SF725-AB

Subject: Differential Lock Buzzer

Models Affected					
Make	Model	Model Yr. Start	Model Yr. End	Prod. Start Date	Prod. End Date
Freightliner	Cascadia	2026	2026	January 14, 2025	January 22, 2025
Identifying Feature	Models spec'd with 87B-009 Pneumatic Switches

SF725 – Modifying DCDL Switch Wiring

Fig. 1, Removing the Connector from the Switch

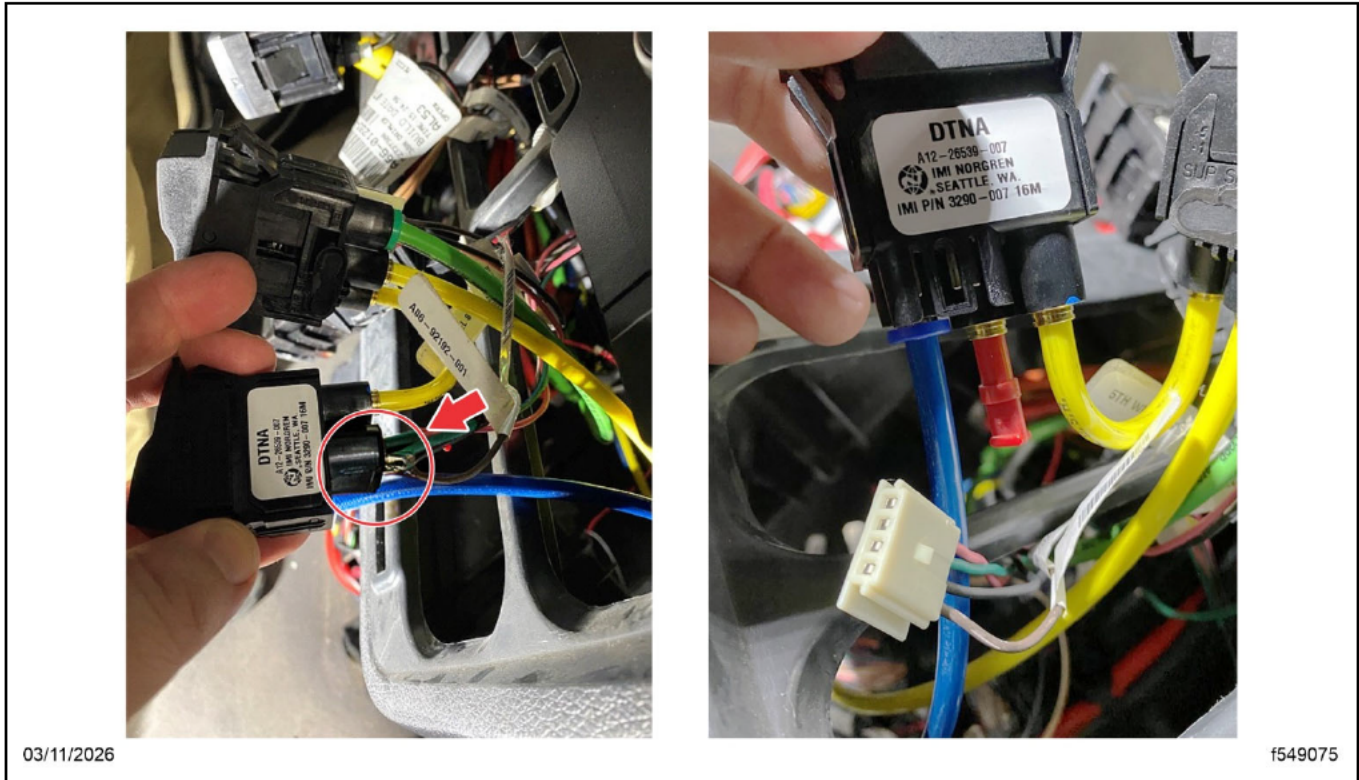
6. Remove the white connector from the back of the switch. See [Fig. 1](#).

Fig. 2, Locating the Splice Packs

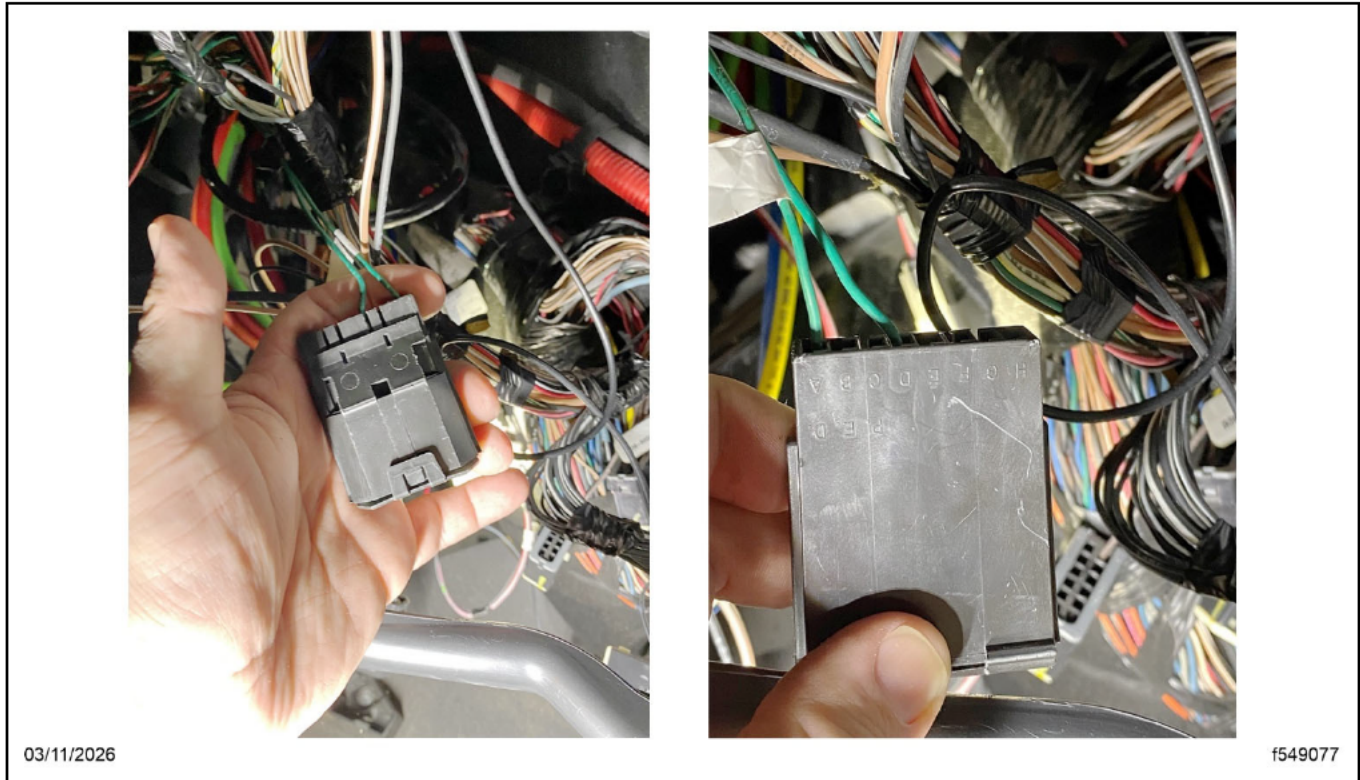
7. Locate the splice packs containing the green wires. See [Fig. 2](#).

8. Identify a wire matching the gauge of the green wires in the splice pack and long enough to reach from the splice pack to the white connector for the DCDL switch. Install the terminal from the kit on one end of the wire.
9. Insert the terminal into an open cavity at the rear of the splice pack.
10. Identify the wire routed from connector cavity B at the rear of the disconnected connector. This wire should be green. Cut the wire five inches from the connector.
11. Connect all three wires:
- the wire from the connector,
 - the new wire from the splice pack, and
 - the other end of the original wire.

Fig. 3, Switch Wiring, One Switch One Feedback

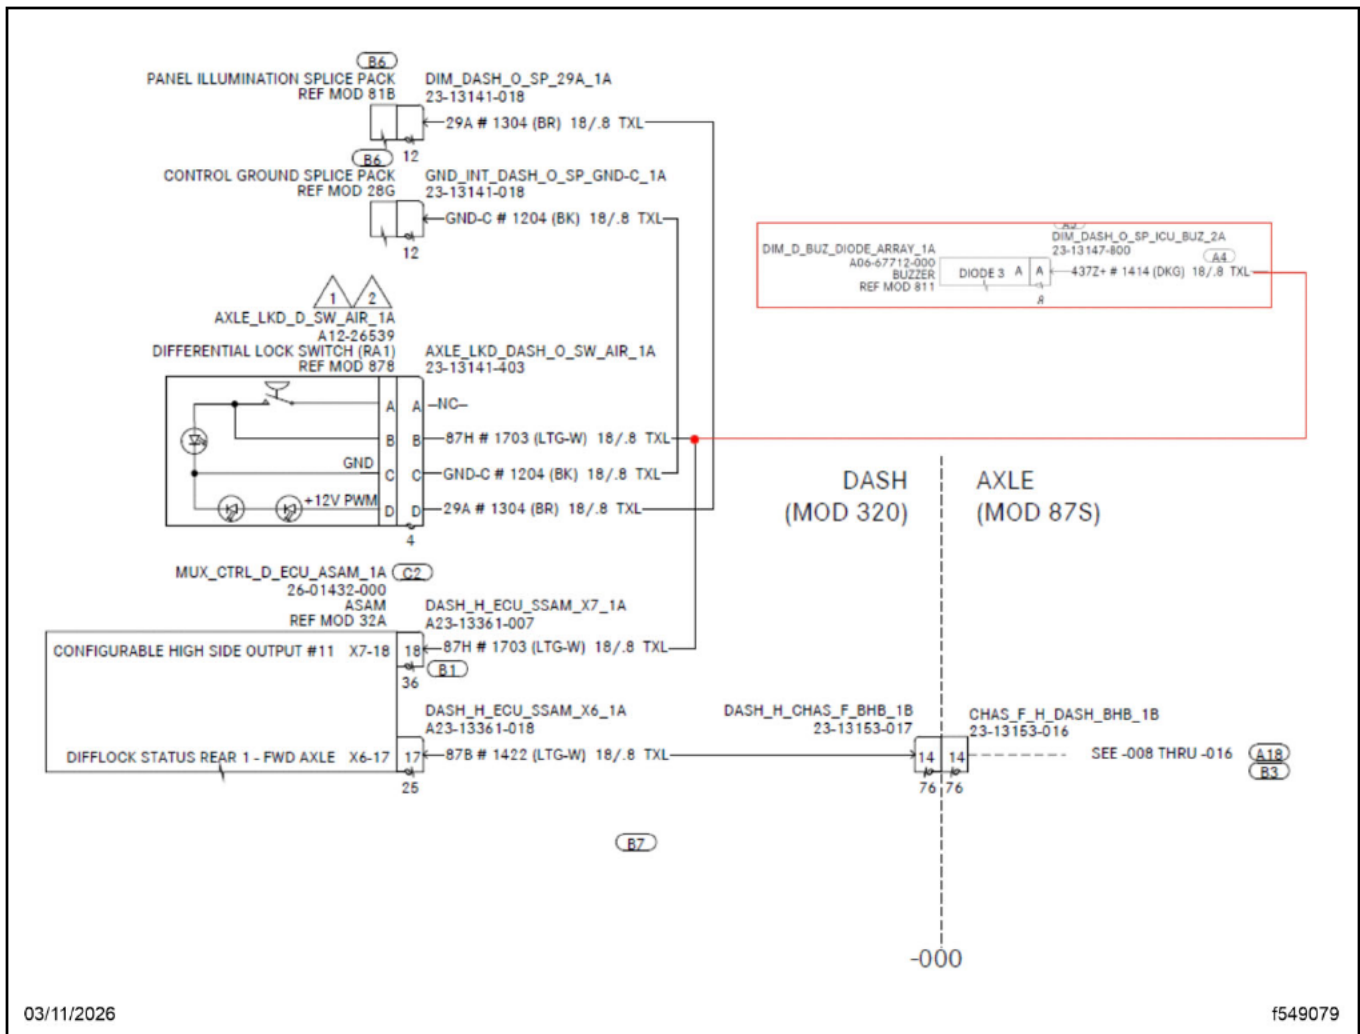
For instructions, see **Group 54: 1.3 Wiring Repair Using Phillips STA-DRY® Solderless Connectors** in the *New Cascadia Workshop Manual*. See switch feedback wiring configurations in [Fig. 3](#), [Fig. 4](#), and [Fig. 5](#).
